## ANN ARBOR HISTORIC DISTRICT COMMISSION

#### **Staff Report**

ADDRESS: 430 South First Street, Application Number HDC16-214

**REPORT DATE:** October 20, 2016

Prop. South Elevation

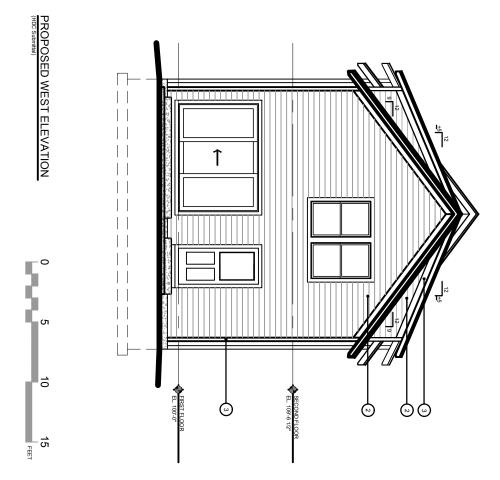
- 3. The roof of the addition features a shed dormer on either side that is reminiscent of the shed roofs on the main body of the house, and the front porch. The one on the north side of the addition has a pair of casement windows, and the one on the south side has no windows. This is a bit awkward looking on paper, but the addition is far enough from the street that it probably won't call attention to itself, and from the backyard the steeper roof pitch is maintained.
